Our ref: M2033
Council ref: CAR22/0477
QA: sj.ap.gm

**Re: Change an Early Referral Entity Response (CAR22/0477)
Proposed High Impact Industry (Mobile/ Fixed Concrete Batching Plant and
Precast Shed) on land described as Lot 20 SP338023 (formerly Lot 700 on
SP331994) and located at 43 Penelope Road, Stuart**

Table 1 – Council Information Request

Issue Date	sep 2022
Drawn	s.parrish
Scale	As indicated
sheet	sk 02
22-038	
printed 20/01/2023 2:23:51 PM

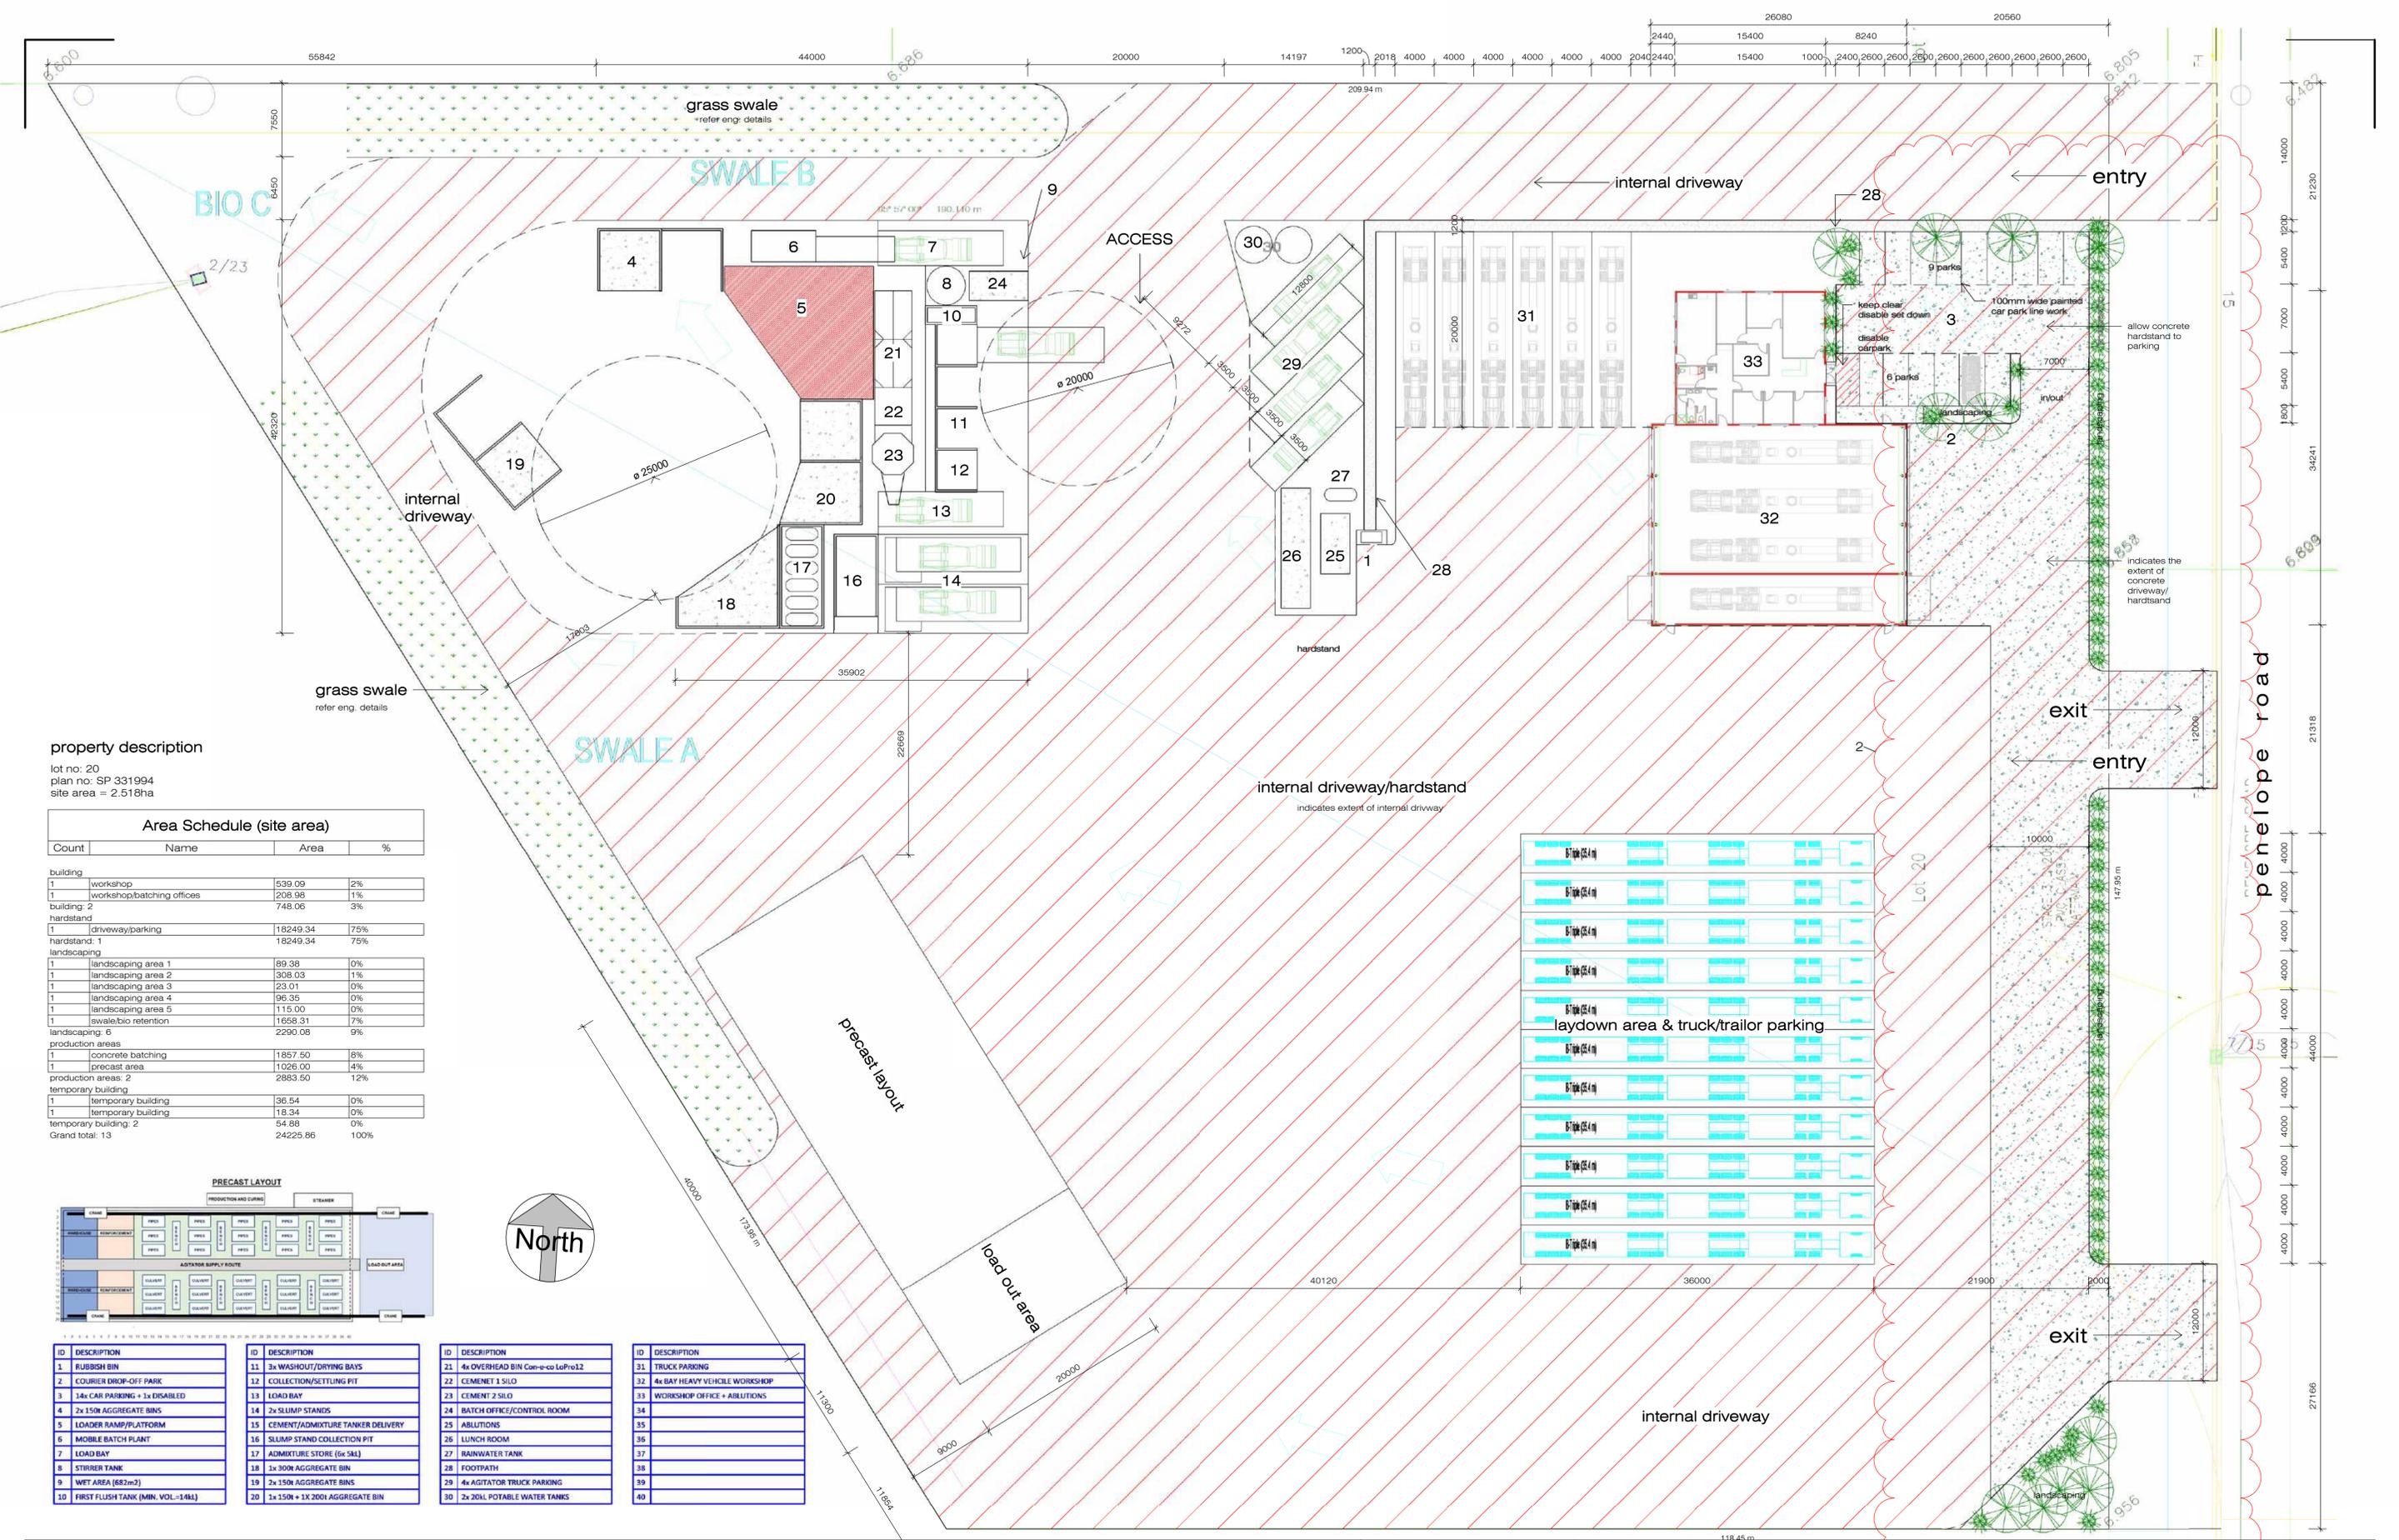
Condition	Reason for Amendments or Deletion	Suggested Wording
Condition 1 Accepted Plans	This condition needs to be updated to reflect the plan references of the amended plans, refer Attachment 2 .	The table will need to reference the latest plans.
Condition 3 Storage	<p>This condition requires all goods, equipment, packaging material or machinery to be stored within a building, so as not be visible from any public road or thoroughfare.</p> <p>In the context of the proposed development and operations associated with the use, the requirements of this condition are not practical or feasible, as external storage will need to occur over the subject site.</p> <p>Within a Medium Impact Industry Precinct, one would expect end users, given the size of the lots and proposed operations, need the flexibility to be able to store goods and equipment outside of any buildings. Given the industrial setting and environment of the subject site, it is not considered that items stored externally will detract from the visual aesthetics of the streetscape or impact on the amenity of adjacent properties.</p>	It is requested that Condition 3 be deleted.

Condition 12 Car parking	<p>It is not feasible to seal all the external areas associated with Lot 20, nor is it necessary to do so to avoid material tracking onto the road.</p> <p>A 10 m long concrete apron will be provided at all exit points to enable fines to drop off vehicle tyres before exiting the subject site.</p> <p>The Batching Office/ Control Room car park will be sealed.</p>	Delete the wording under the advice part of Condition 12 and reference the amended plans showing the concrete aprons in Condition 1.
Condition 13 Landscaping	<p>The Applicant is accepting of planting street trees in accordance with the planning scheme.</p> <p>The plans have been amended to address 13 b) and 13 d), refer Attachment 2.</p> <p>The planting of shade trees in the bio basin areas and or the swales, is not practical from a functionality and maintenance perspective. Further, it is unlikely the swales will be visible for the street and as such, it is considered there is justification to delete 13 c).</p>	Delete a) to d) of Condition 13.

No	Description	Date
1	additional information	22.12.05
2	add concrete hardstand/driveway/parking	23.01.13
